RAI 4.6.3-1

RNP Response:

Comparison of Thickness Predictions

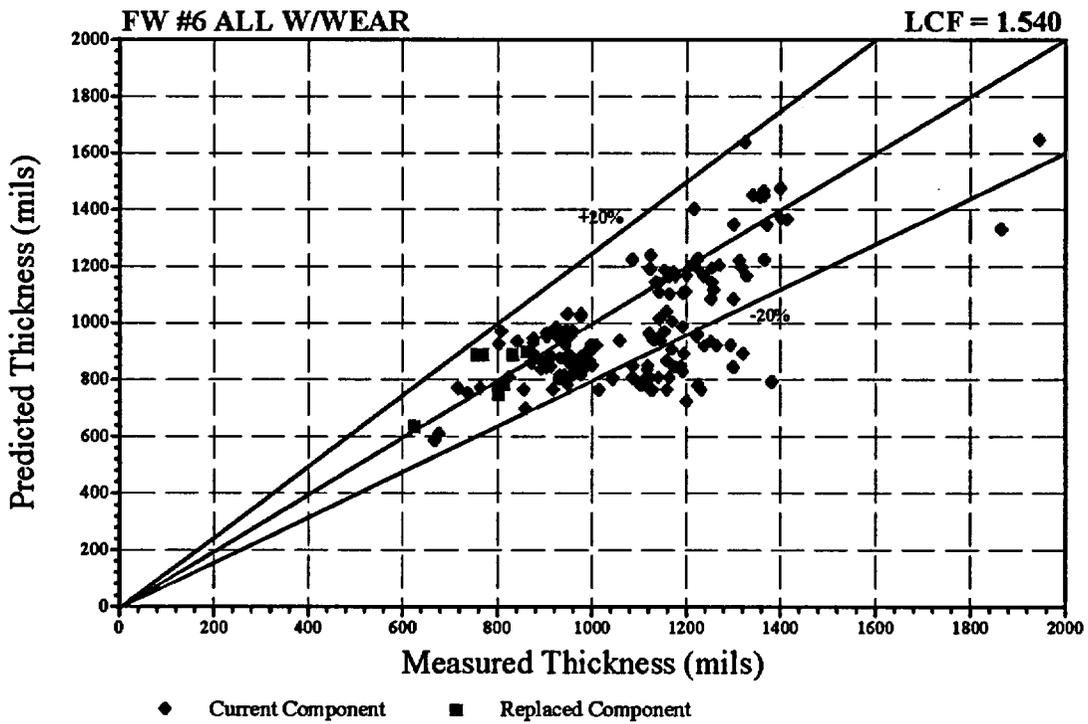
The FAC program in RNP includes prediction of the wall thinning for the components susceptible FAC. The wall thinning is predicted by the EPRI's CHECWORKS computer code. In order to allow the staff to evaluate the accuracy of these predictions, the applicant should provide a few examples of the components for which wall thinning is predicted by the code and at the same time measured by ultrasonic examination or any other measurement method employed in the RNP. This procedure will show the effectiveness of CHECWORKS in predicting the as-found condition.

Below is a chart that provides comparisons of predicted versus as-found thicknesses for RNP feedwater piping. The thickness prediction is based on initial thickness (nominal wall) minus the predicted wear over the life of the component. The predicted wear is calculated initially assuming no known wear. The wear is then adjusted based on actual measurements of many components within a line. The adjustment is a correction factor which is applied to the predicted wear in the components in the line. Normally, some components will wear less than predicted and some will wear more than predicted. The line correction factor (LCF) is derived by calculating an adjustment factor for each component, then taking the median value of these individual adjustments as the line correction factor. The actual thickness measurements vary from predictions due to variations in initial pipe wall thickness, e.g., some components are substantially thicker than nominal. The data points in the non-conservative direction are a result of higher than median wear, combined with initial thickness values close to nominal.

Also provided below are data sheets from several systems within the program scope. These data sheets contain data points (in inches) for measured thickness, predicted thickness, and minimum allowable thickness.
